**COUNTY OF SAN MATEO
PLANNING AND BUILDING DEPARTMENT**

SUBJECT: EXECUTIVE SUMMARY: Consideration of a Design Review Permit, Coastal Development Permit, Non-Conforming Use Permit, and Grading Permit, to allow construction of a new two-story, 1,590 sq. ft. single-family residence with an attached 418 sq. ft. garage and 800 sq. ft. Accessory Dwelling Unit (ADU), on a legal 4,800 sq. ft. non-conforming parcel, in the unincorporated Miramar area of San Mateo County. The use permit is required to allow development on a less than 5,000 sq. ft. parcel, where 10,000 sq. ft. is the minimum lot size in the S-94 Zoning District and to allow reduced side setbacks of 5 feet 3.5 inches where 10 feet is required. The project involves 290 c.y. of earthwork and approximately 73 feet road extension of Alto Avenue. The project is not appealable to the California Coastal Commission. In conjunction with the requested permits, it is recommended that the Planning Commission determine that the project is categorically exempt from California Environmental Quality Act (CEQA) pursuant to CEQA Guidelines Section 15303.

County File Number: PLN 2021-00101 (McGregor)

D2-0
Scale: As Noted
Sheet size: Arch D

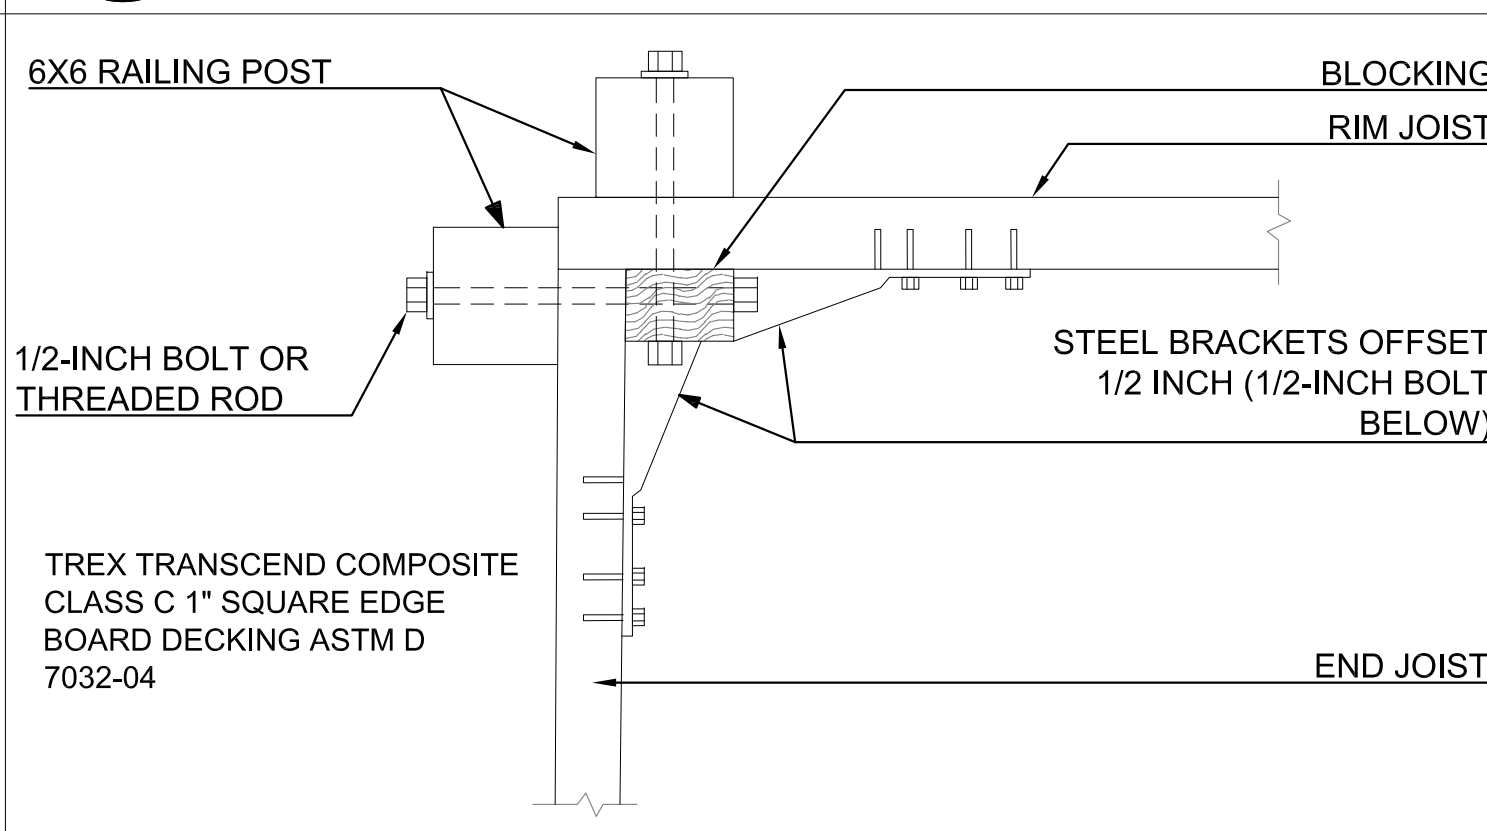
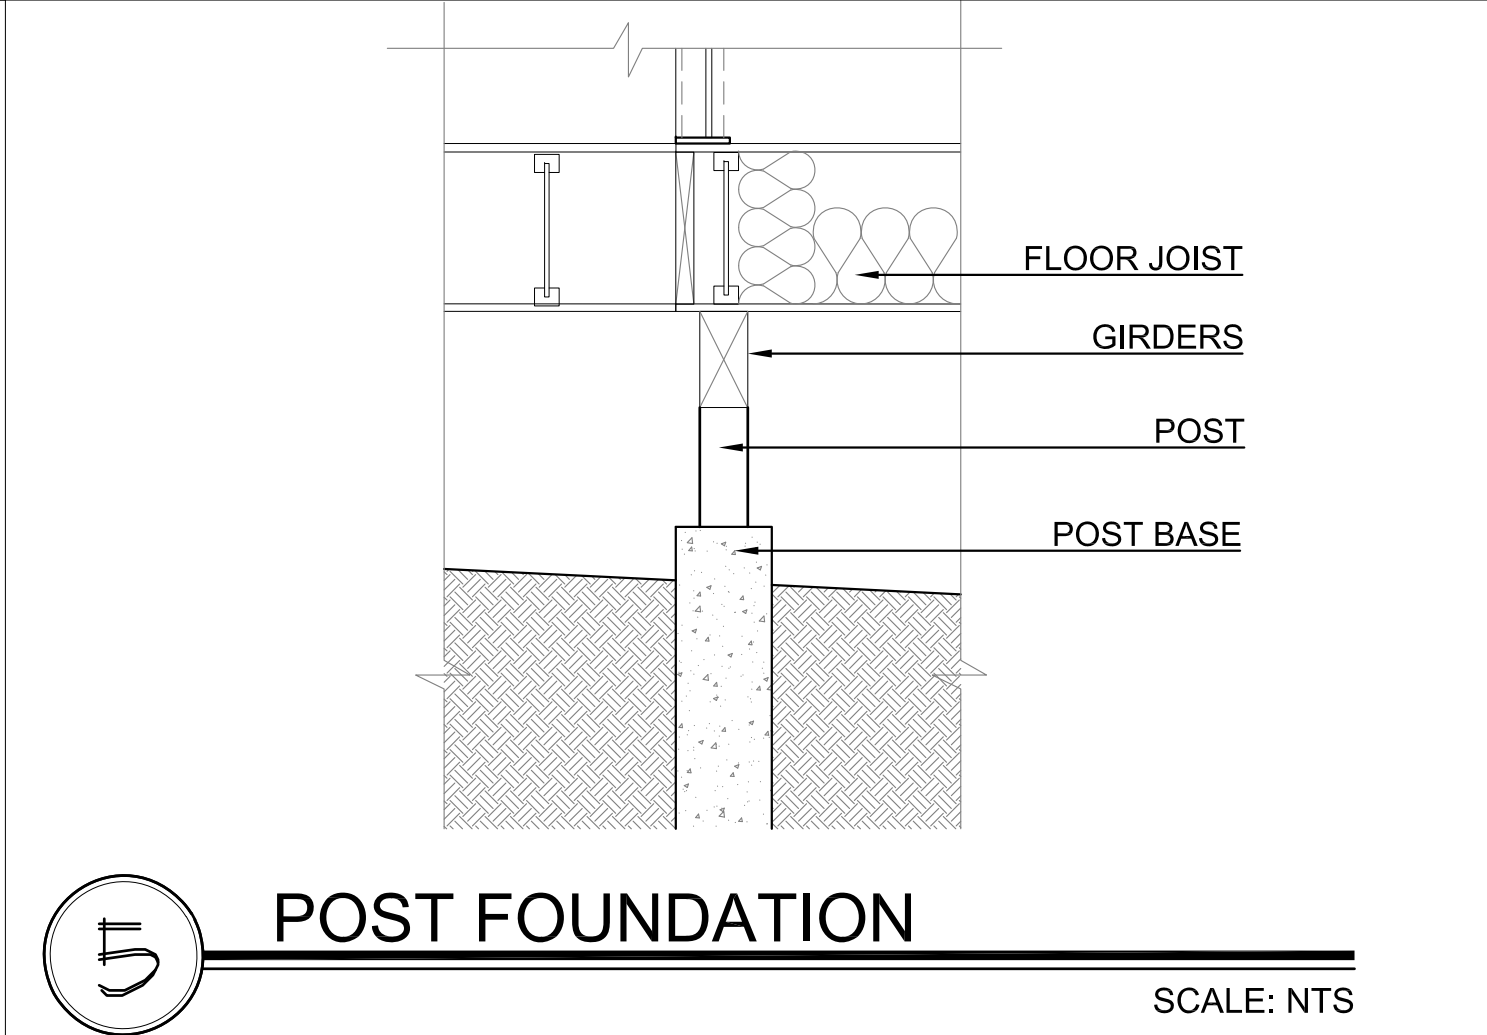
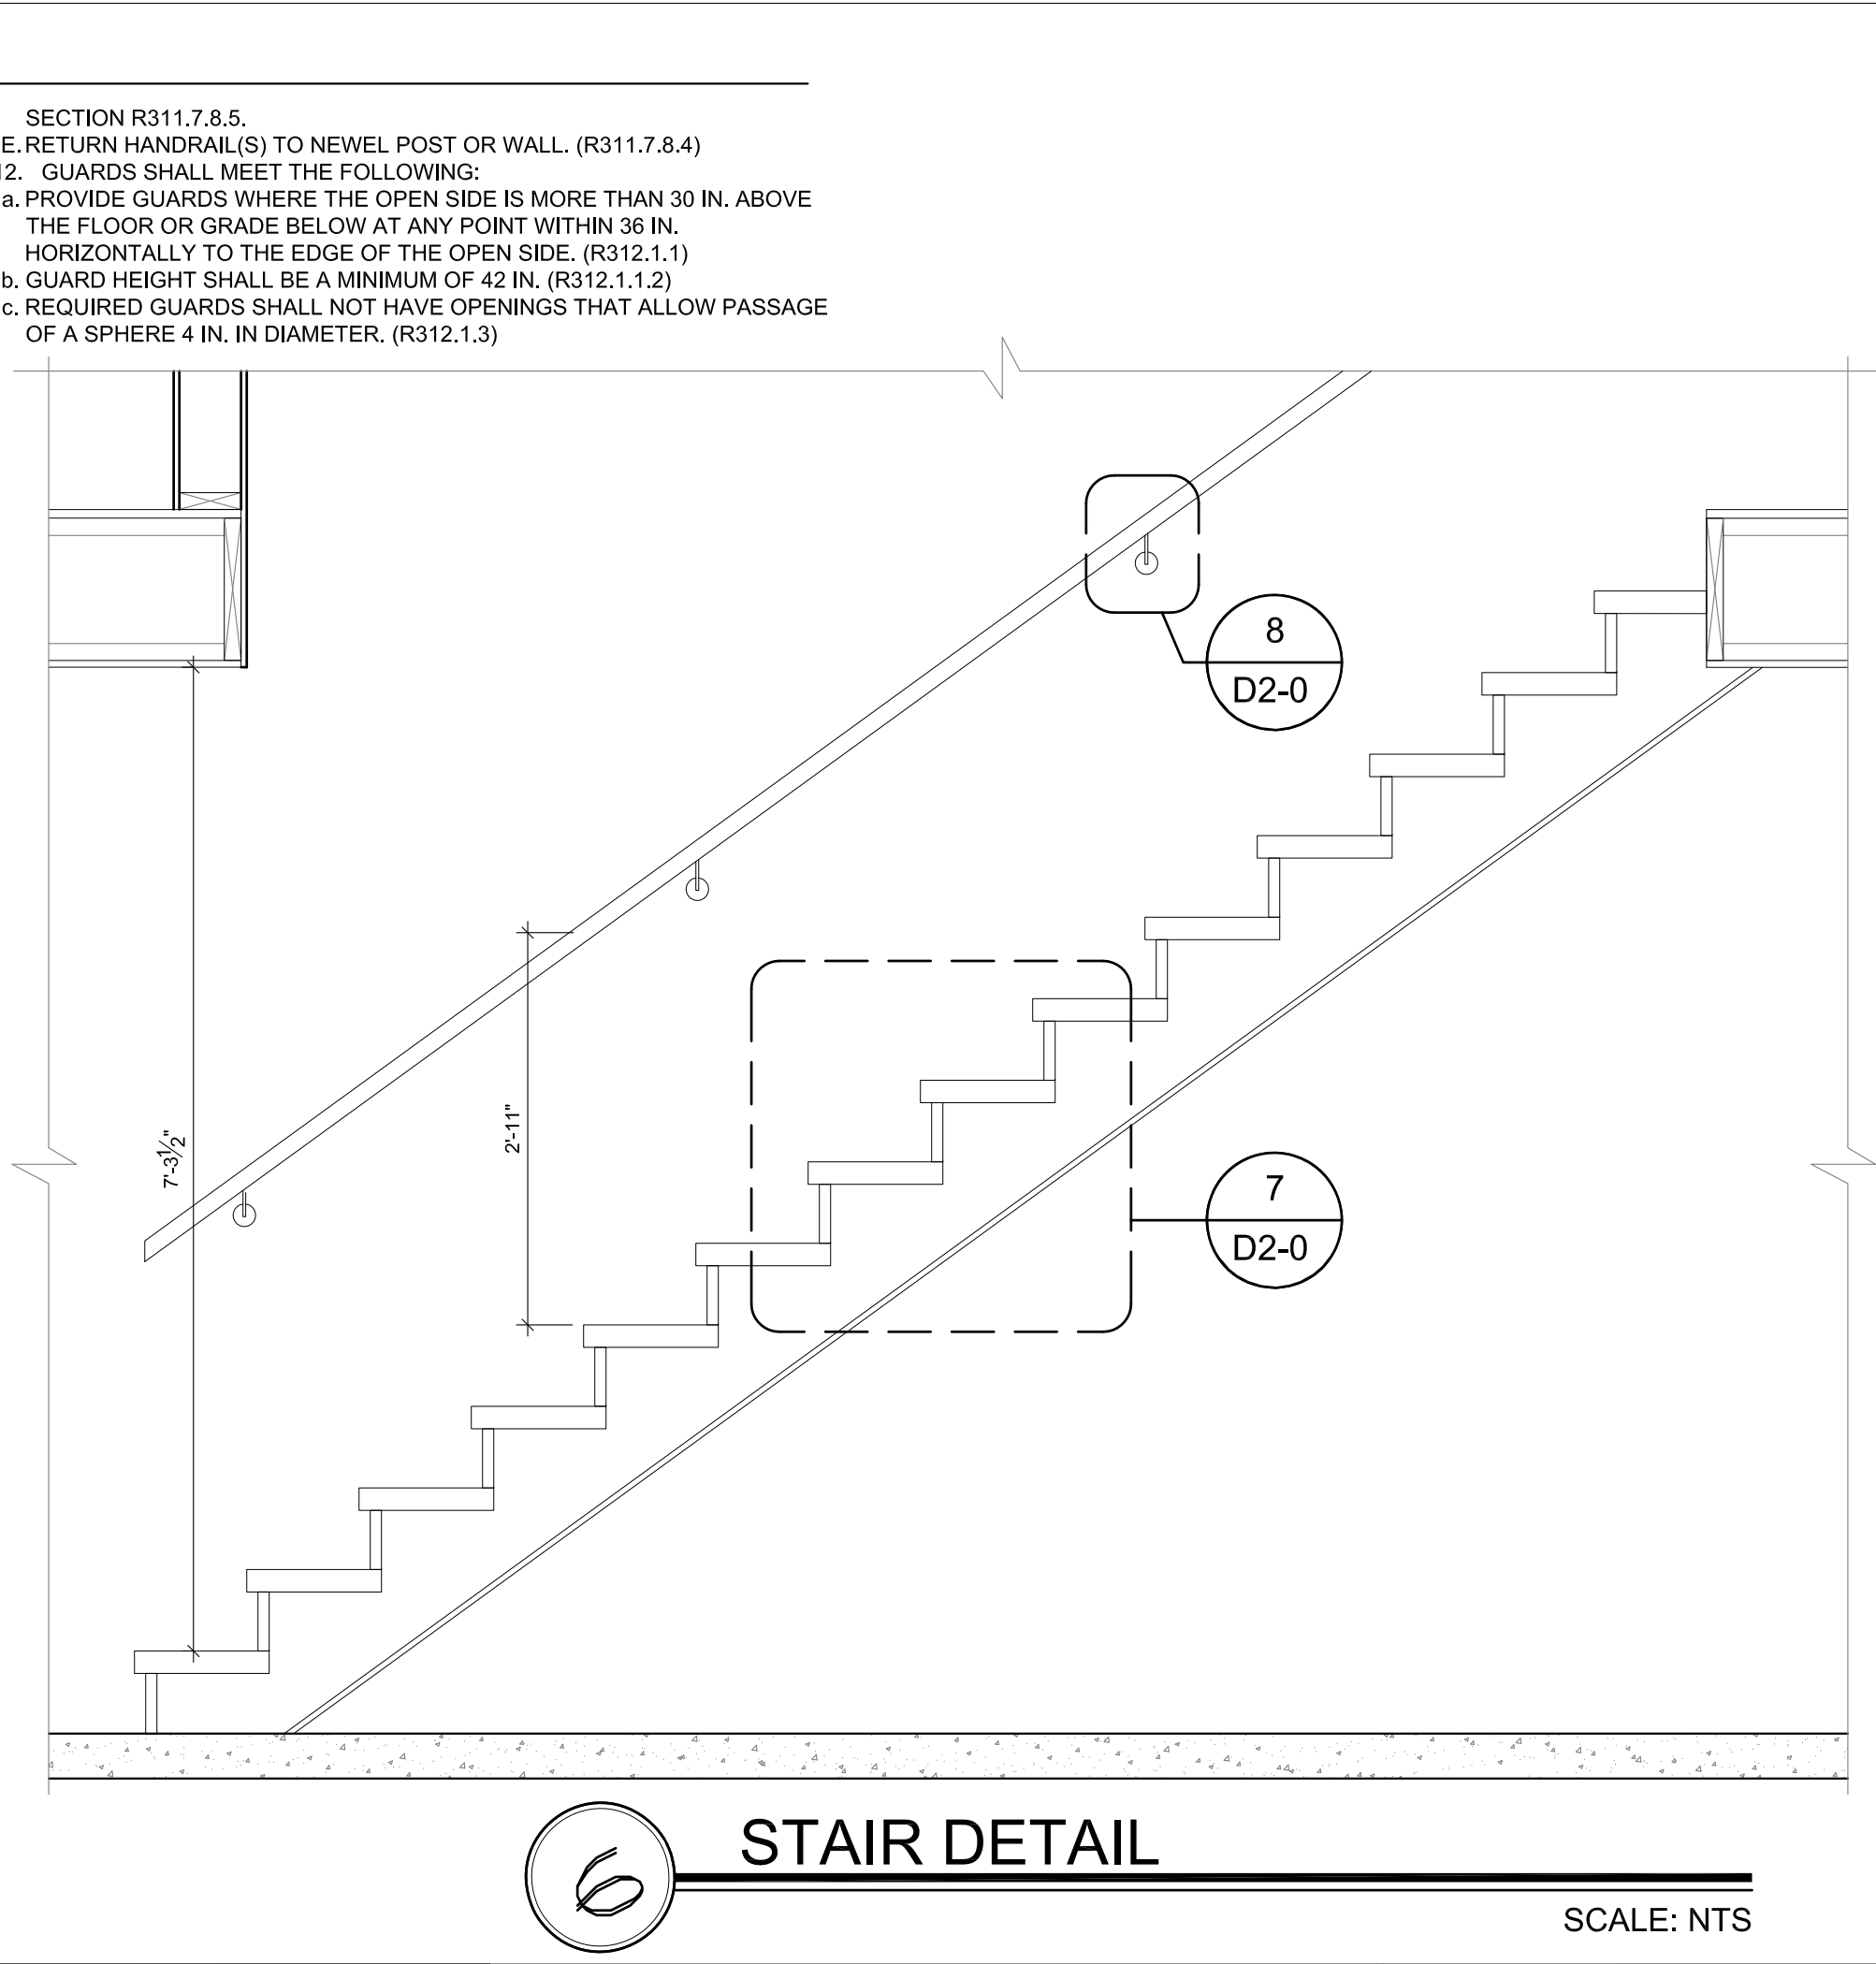
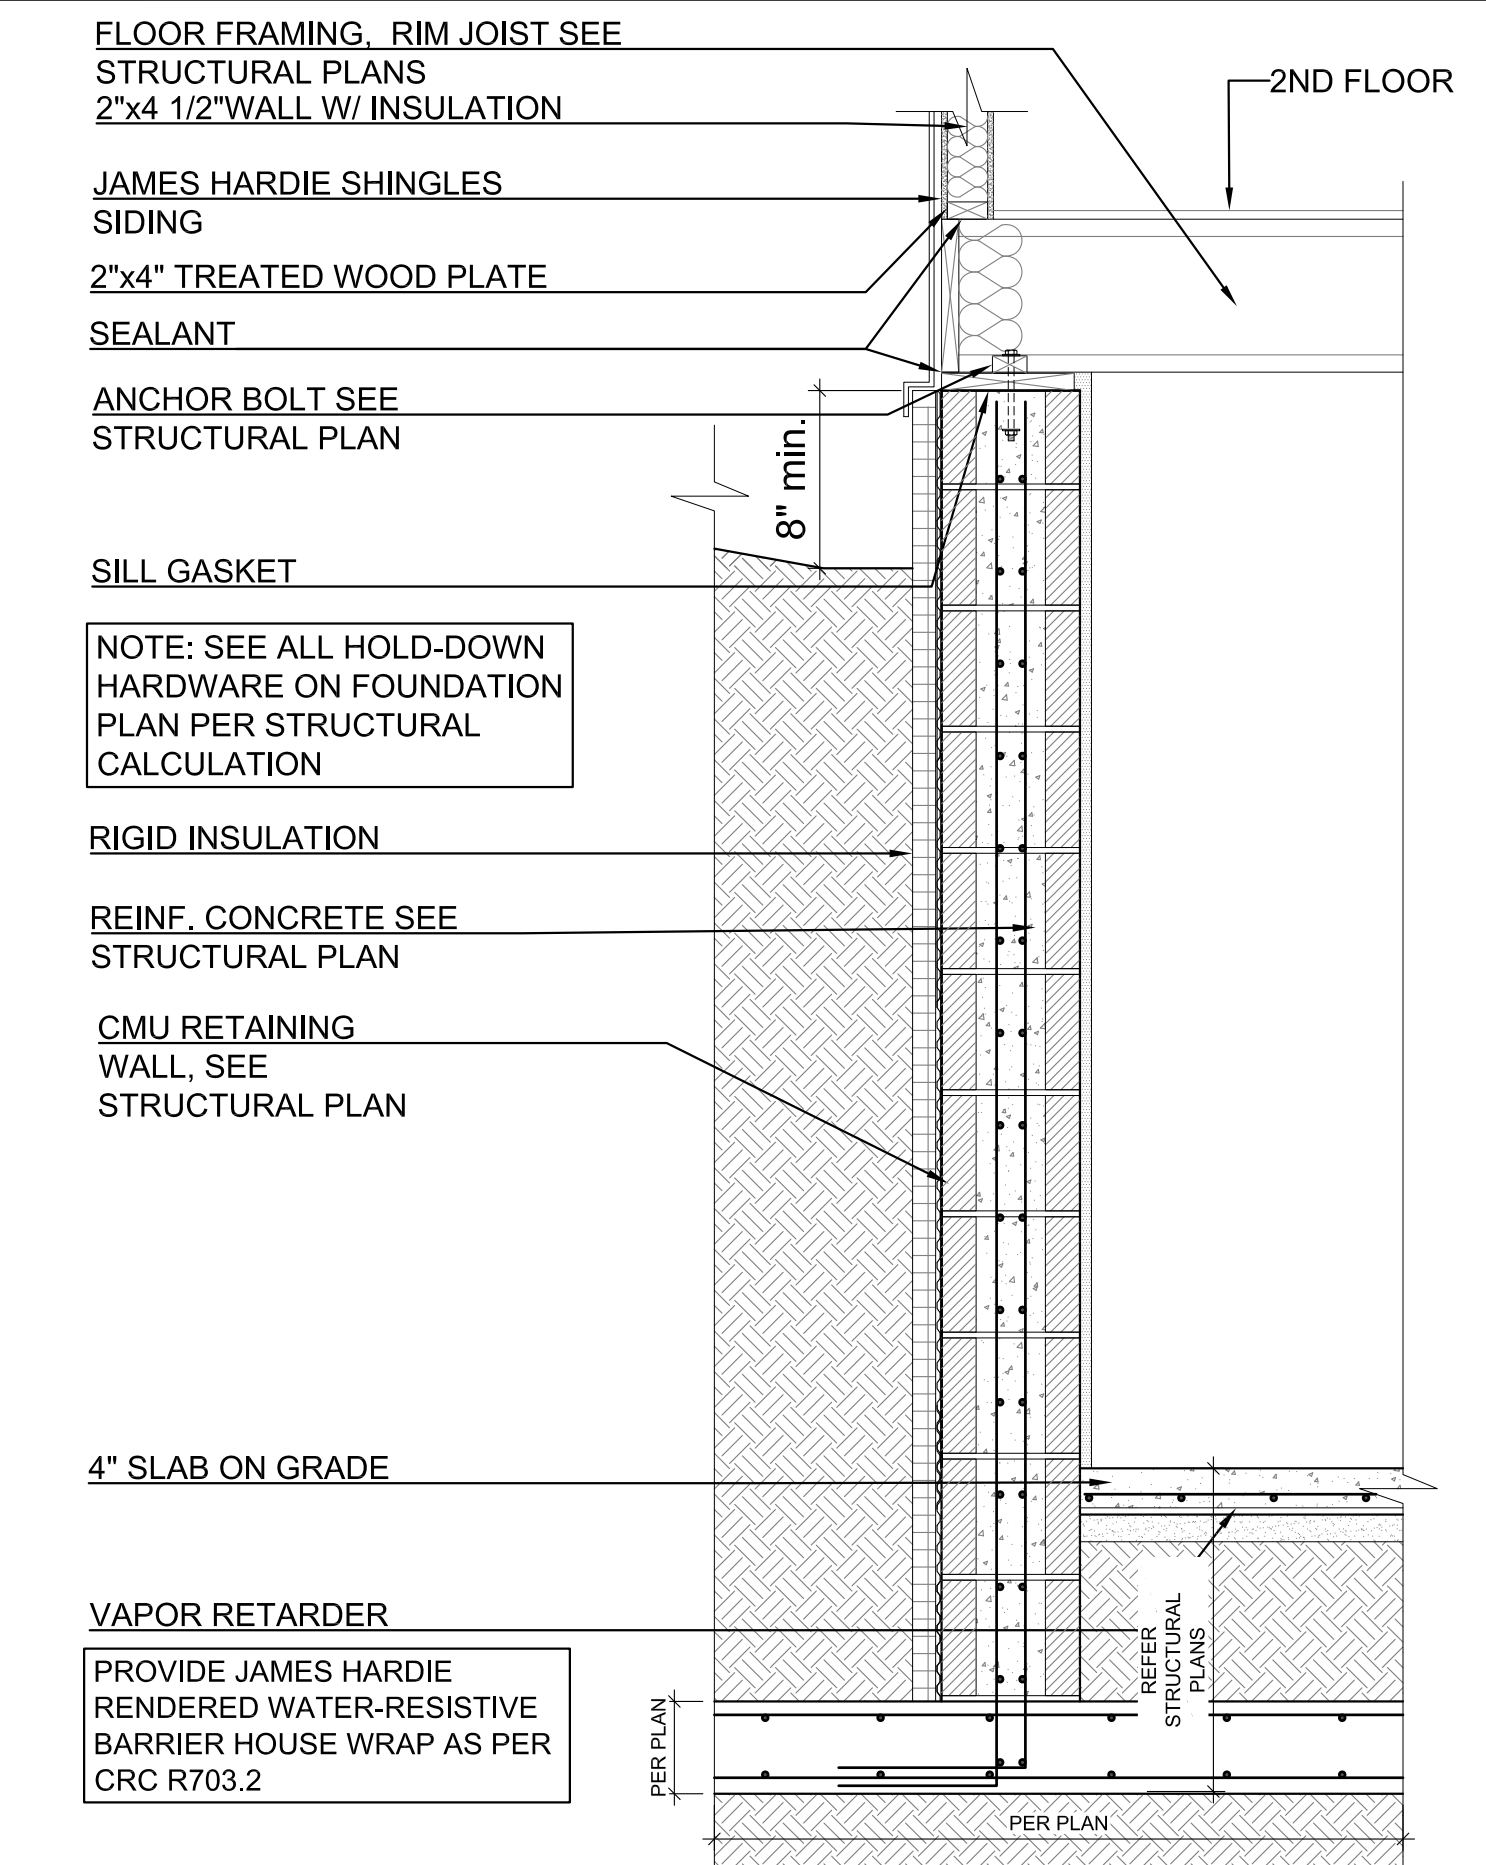
- d. Reconsider grading at rear patio to determine if guard rail is necessary. If guard rail is required, applicant shall match the specification on Sheet D2-0.
